STAFF REPORT

TO: PLANNING COMMISSION

LOCATION: 1020 West Arlington Way (APN 372-121-057)

PROPOSAL: Public hearing on an appeal of the approval decision of the Zoning Administrator to grant Use Permit, Variance and Design Review approvals to expand an existing 2-car garage structure within the front yard, adding parking for 2 additional cars and an approximate 800 sq. ft. studio above. Use Permit approval is required to allow an Accessory Structure over 1,000 square feet in size, with a height of approximately 18 feet when a maximum of 15 feet is normally allowed. Variance approval is required to allow new construction without a front yard, where a minimum 20' yard is normally required.

FRONT YARD

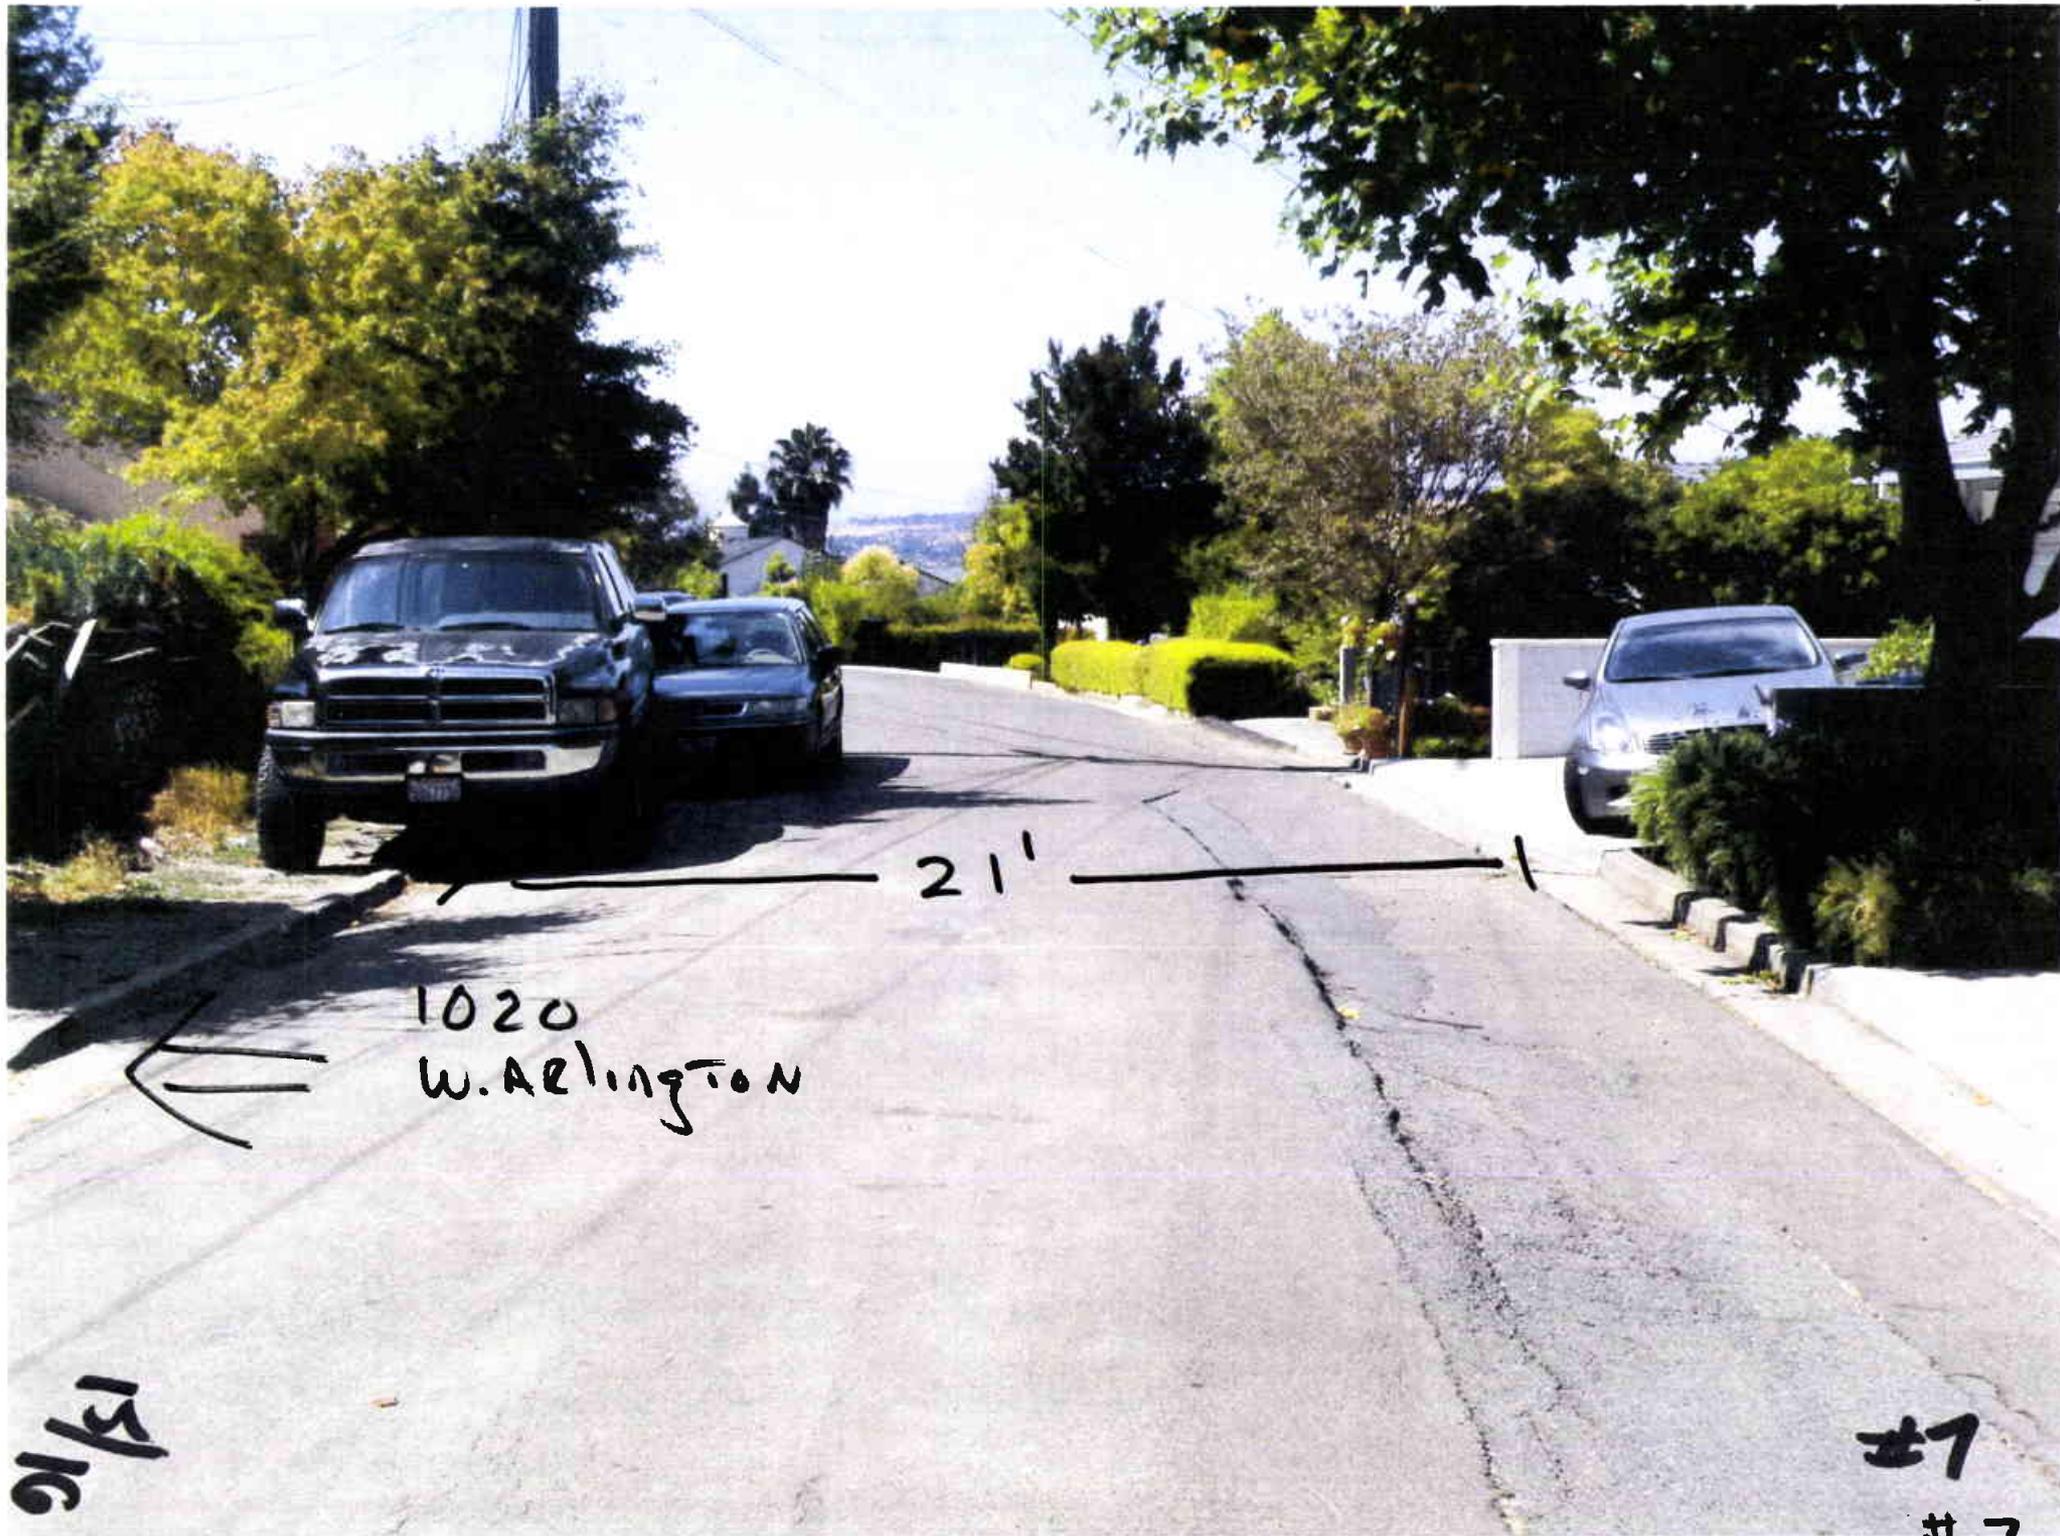
The issue is whether a building 58 feet in length, two stories high, can be described as “diminutive” in comparison to the main residence. The placement of this building at street level actually hides part of the main residence, and the tower stairwell placement for this structure on the south side of the new building will actually replace the front stairs to the primary residence, obscuring the main entrance to the primary residence. **In effect, the primary residence becomes secondary, and the accessory living space becomes the primary focal point.** The ordinance allowing an accessory structure stresses that these structures are to be “subordinate” to the primary residence. Furthermore, the building of a four-car garage in a zoned R-6 area is inappropriate, leading one to perhaps assume that a duplex structure has been built with 4 garages.

The applicant's proposal to create a 1,950 sq. ft. structure, 22 ½ ft. high, 58 ft long, and with no setback from the street is not consistent with the character of the neighborhood and not consistent with established zoning regulations. In 2003 the Planning Commission would not allow an owner to build a 22 ½ ft. high garage on property located 2 houses from this property. The size of this proposed accessory structure is larger than some of the other houses on this street. In fact, this structure could easily be called a "carriage house" since it contains an independent living space above the four car garage. Its placement on the property hides the primary residence and thus makes it the most visually prominent structure on the property, which is not the intent of the city code.

KRAMER PROPOSED FRONT ELEVATION
(1ST PROPOSAL 6-23-11)

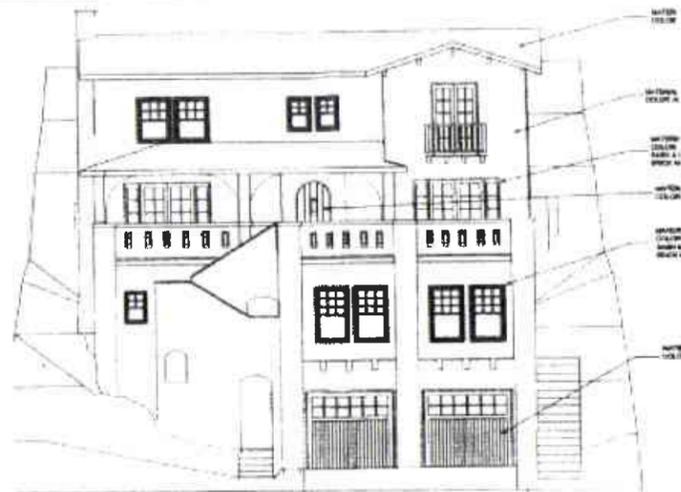
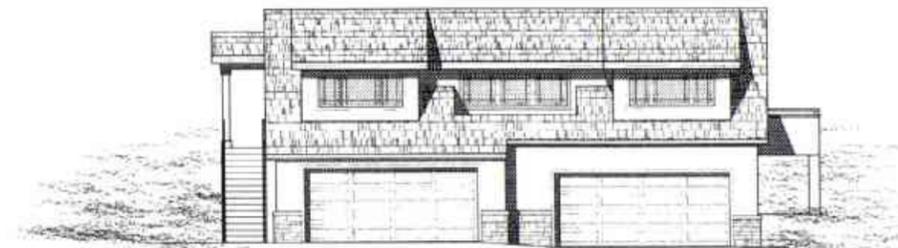
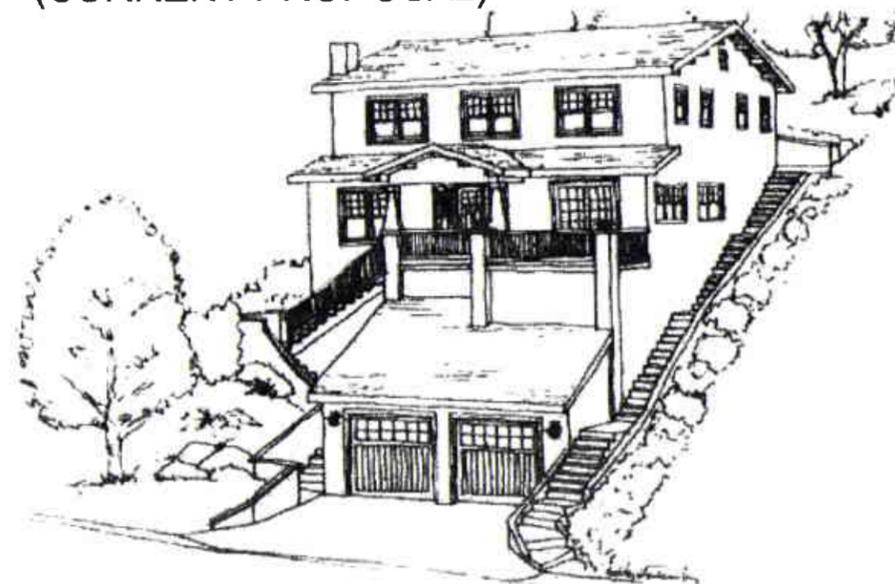
Response to Appeal: Subsequent to the filing of the appeal, the applicant has agreed to modify the design from what was approved by the Zoning Administrator to better address the neighbors' stated desire for a more diminutive building profile - one that more closely echoes the design that was ultimately approved for 1042 West Arlington Way. The modified design lowers building height from 22½' to 18', by replacing the gabled dormers with shed dormers and removes the streetside balcony and enclosed stair/entry (thus an approximate 100 sq. ft. reduction in the structures'

The Planning Commission set a precedent against exceeding the height requirements on February 11, 2003 when it denied a request to build a 22 ½ ft. high two-car garage at 1042 West Arlington Way, agreeing that the height was excessive.

Finding to Deny Appeal Issue #1: The Planning Commission’s action regarding the 1042 West Arlington Way project did not establish a precedent for the denial of future requests to grant exceptions to the normal height limitations. The Commission’s February 2003 denial rejected a specific design which inappropriately placed a unbroken 22½ ft. “gabled end” high wall, with a full story above the garage, 3 ft. from the front property line.

Facts in Support of Finding: **The design for 1042 West Arlington Way, which, albeit revised, was approved by City Council on appeal in June 2003. The Council concurred with the Commission that the two story high “gabled end” wall was indeed inappropriate, but did approve the project with a shed roof above the one-story garage face. The applicant’s design echo’s the Council’s 2003 approval for 1042 West Arlington Way, in that shed roofs are used to diminish the appearance of height and that the second level is deemphasized by the use of shed roofed dormer windows.**
